**ADDENDUM #1**

**REQUEST FOR BID (RFB)  
NO. 2026-025**

**Solicitation Title:** Crown Farm Park Construction

**Issued By:** City of Gaithersburg  
Procurement Division  
31 S Summit Avenue  
Gaithersburg, Maryland 20877

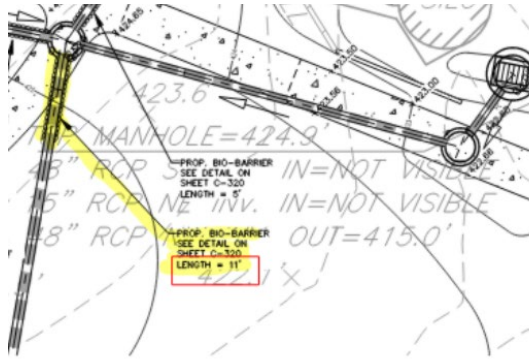
- Q.1.** See Sheet C-310, please confirm if the thick dashed lines that come in sets of "3" are for the bio barrier?
- A.** The thick dashed lines represent the pipe. See the image below, clipped from sheet C-310, showing a typical callout/notation for the biobarriers.
